# A G E N D A

## Architectural Review Board

December 15, 2021 – 5:30 p.m.

**LANDSCAPE PLAN**

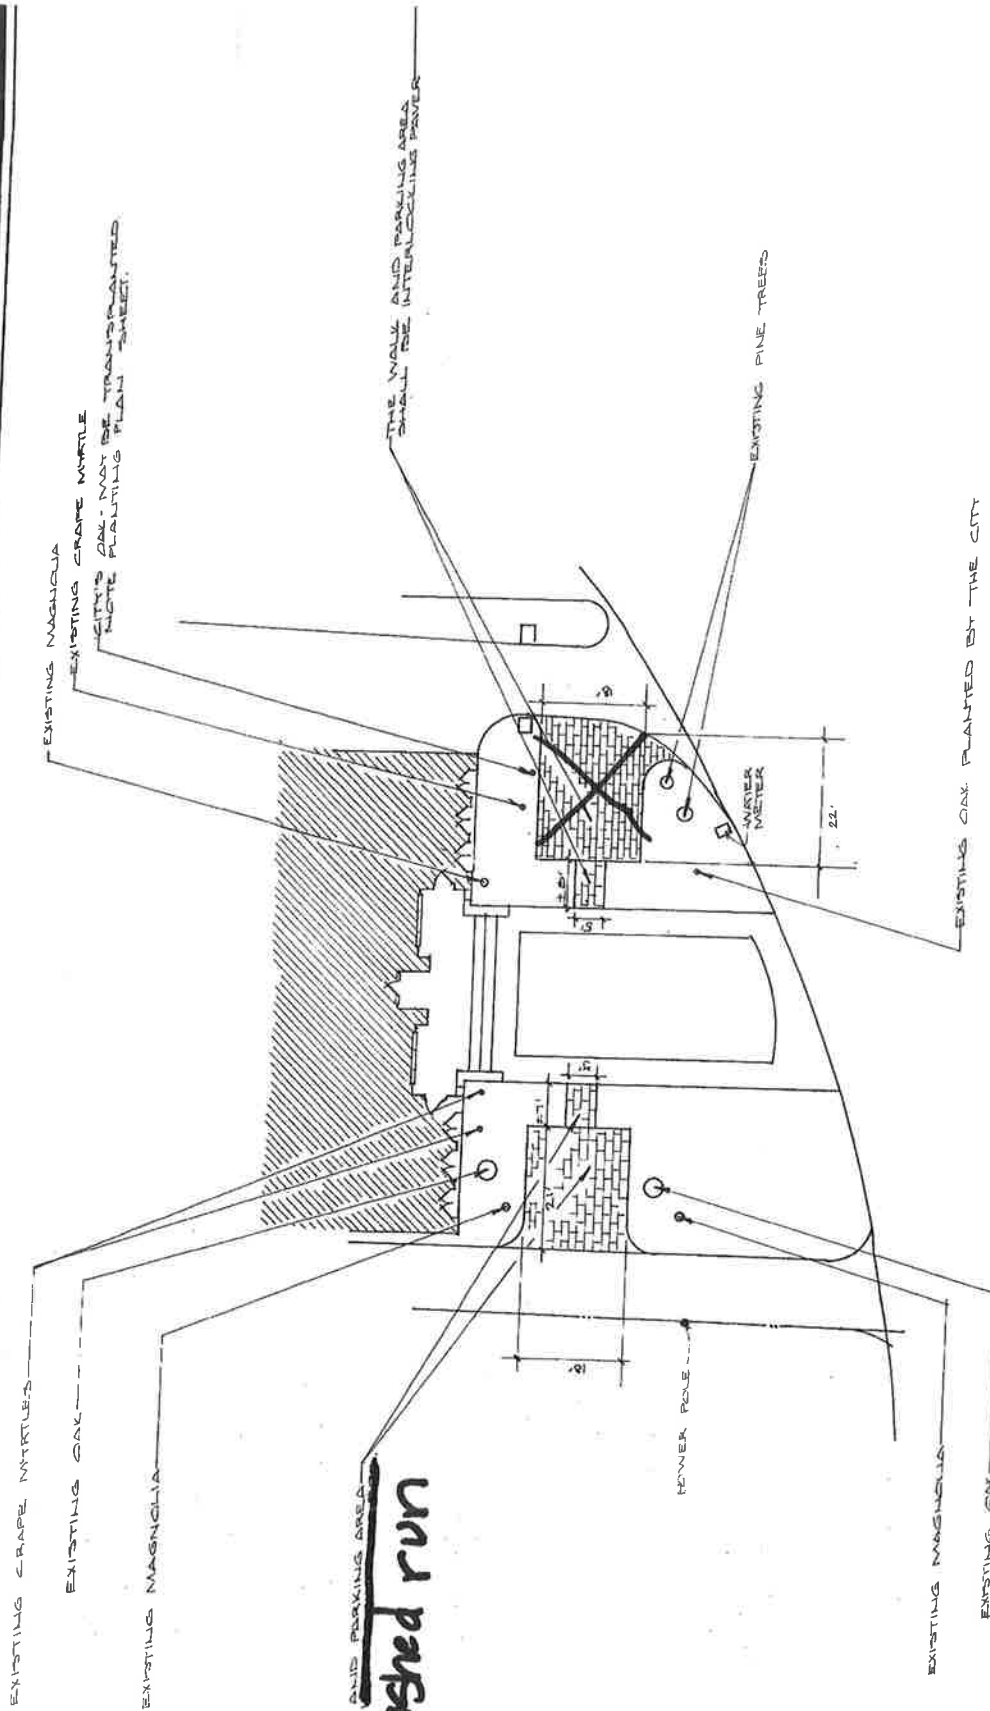
- Loose paving material (gravel, etc.) will be much better for tree survival.

~~1919 Norman Bridge Road~~ 1826 S Hull

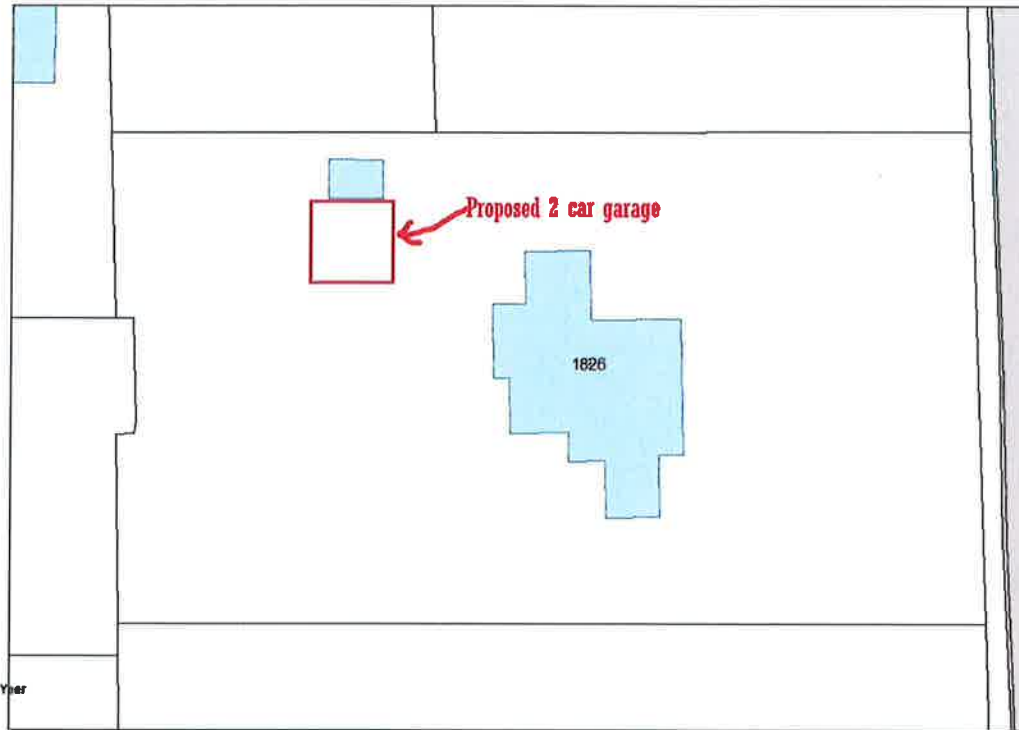
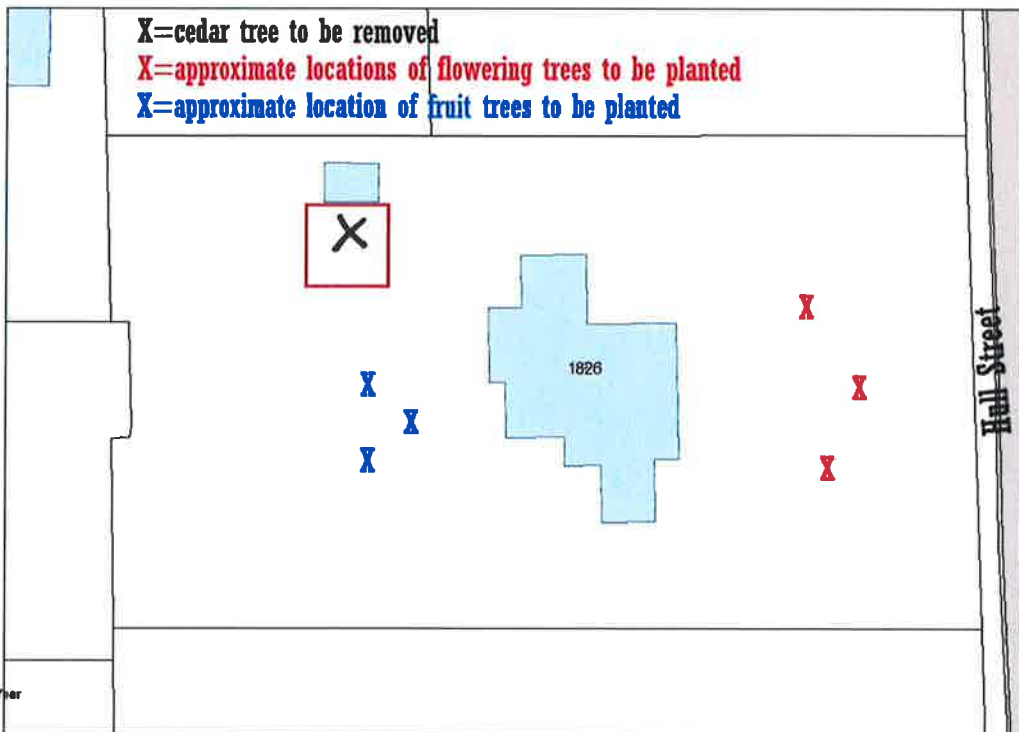
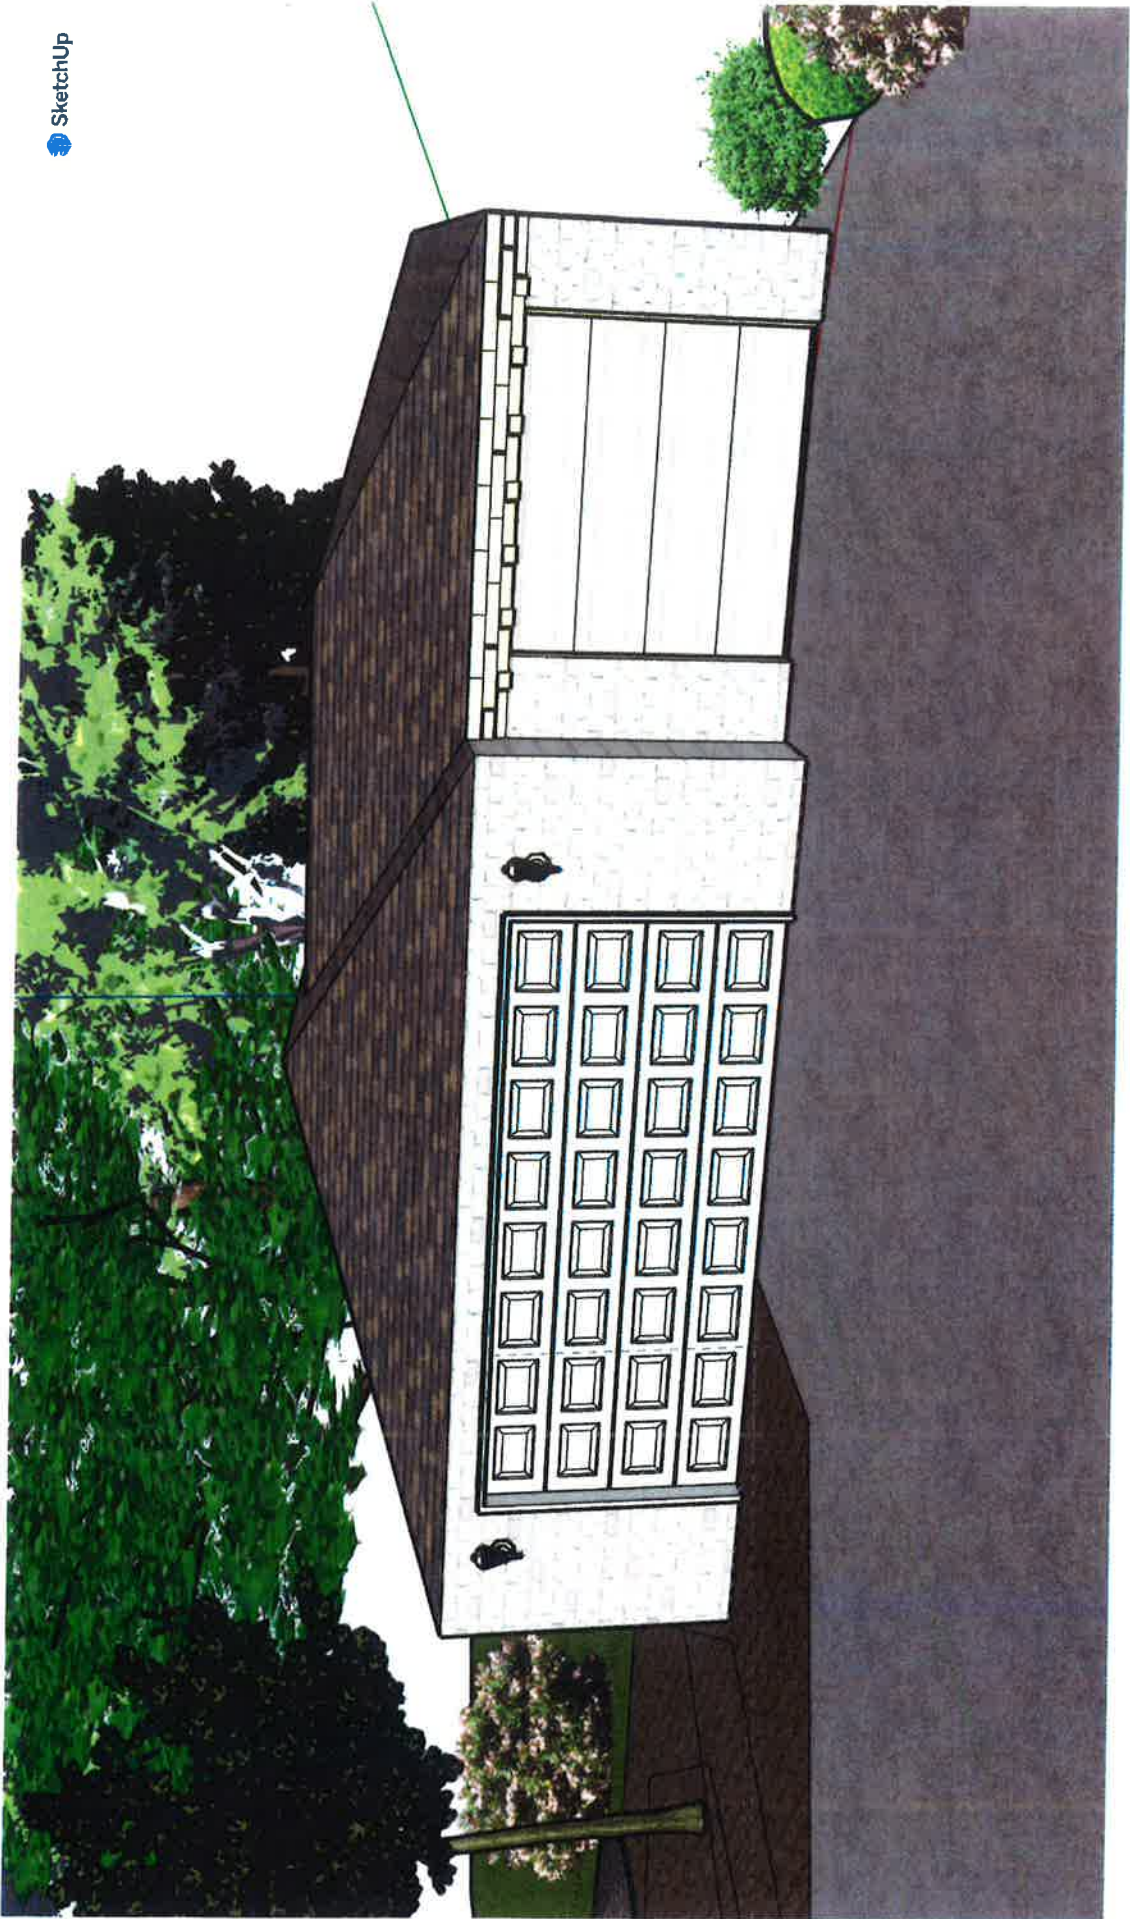
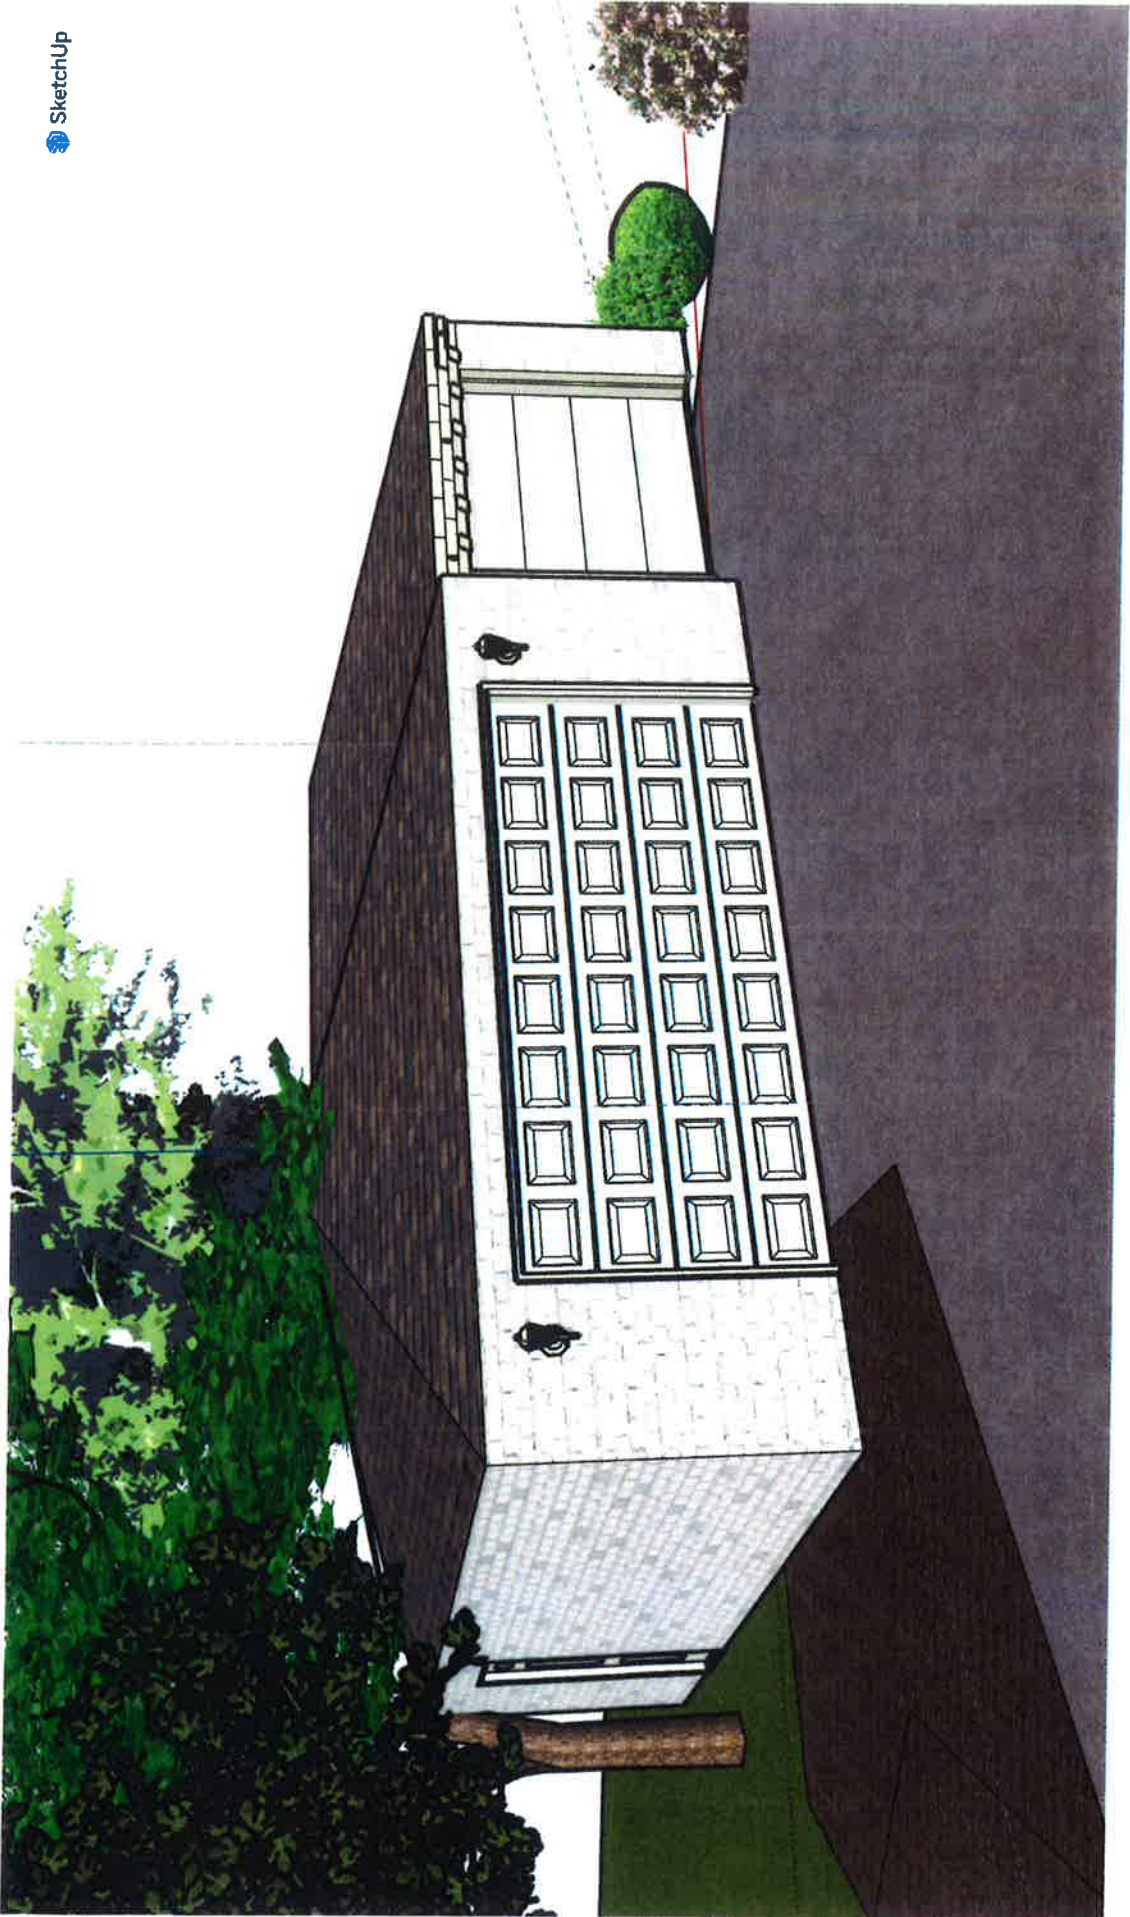
- The current garage is too small to function well for most modern vehicles. The addition will incorporate the original garage and provide additional parking and storage space.
- Material of the garage door has not been specified, but steel has been approved on outbuildings.
- A canopy tree will need to be used to replace the proposed removal. Magnolia is a flowering canopy tree.
